BROWNS FERRY NUCLEAR PLANT, UNIT NO. 1

AMENDMENT TO FACILITY OPERATING LICENSE

Amendment No. 76  
License No. DPR-33

ATTACHMENT TO LICENSE AMENDMENT NO. 76

Figure 3.3.K-1  
NCPR LIMITS\*

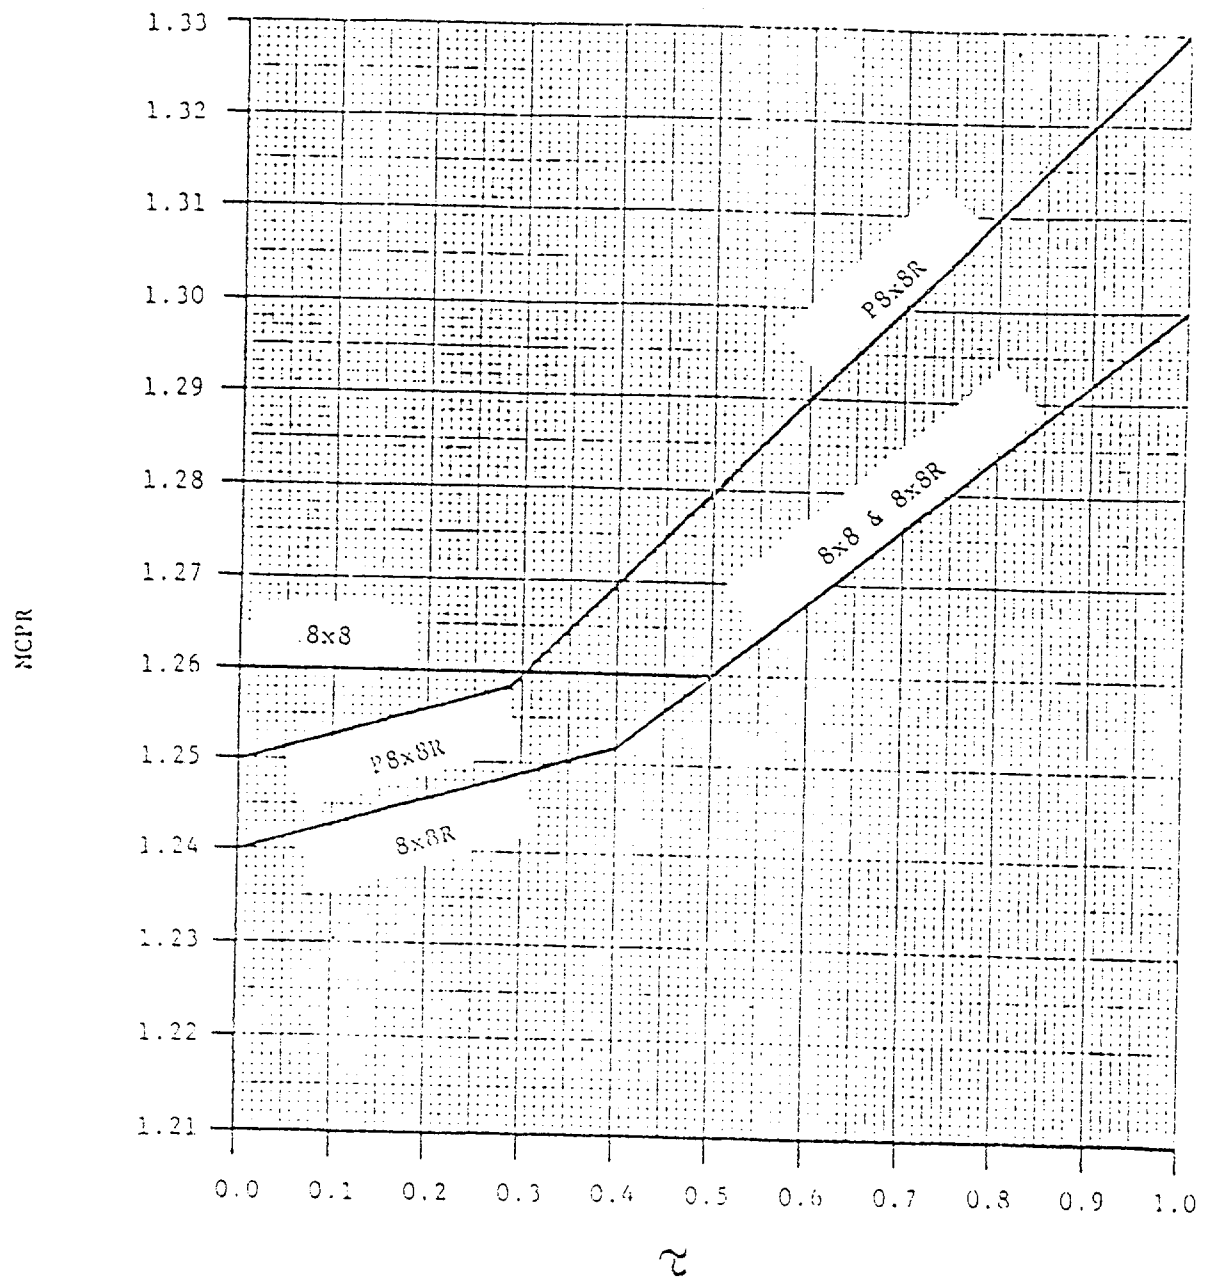
Pgs 160 and 172b - As supported by the reload submittal, the operating limit MCPR's are being changed. Since the MCPR's were determined by the OLYN Code (rather than the REDY Code), OLMCPR's are now calculated from two curves rather than being a single value (or a ramp change with fuel exposure).
